## Evaporator Icing Countermeasure

There is a possibility that icing could occur in the evaporator core of A/C-equipped 2002-2003 Impreza vehicles, up to October 2002, VIN 3\*511336 (sedan) and 3\*801514 (wagon). During operation under warm, high humidity conditions the customer would notice a diminished output of air from the dash vents causing the cabin temperature to rise. The icing condition can be eliminated by replacing the original thermosensor with a new fin sensitive type sensor and placing it in the proper location.

*Refrigerant Thermosensor*

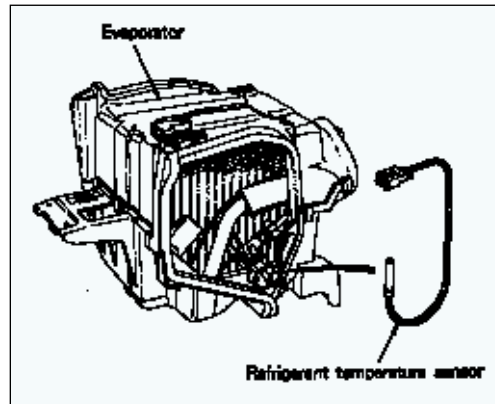
The location of the original thermosensor will depend on the production date of the vehicle. In December 2001, it was moved to the right side of the evaporator. You will replace the surface mounted probe with the internal fin-mounted probe if the condition still exists on vehicles up to the production change listed here.

16. Remove the old surface mounted thermosensor and discard it. Replace it with the new style internal thermosensor P/N 72166FE010 at the new location as shown in the picture in this bulletin. The metal thermosensor goes in the eighth row from the right and 30 mm up from the bottom fin. Assemble the thermosensor and the plastic holder first, then push them both into position. The plastic tab goes to the right of the metal thermosensor in the seventh row.

The part number for the new thermosensor is 72166FE010 and the O-rings needed are 73039FA100 and 73039FA110.
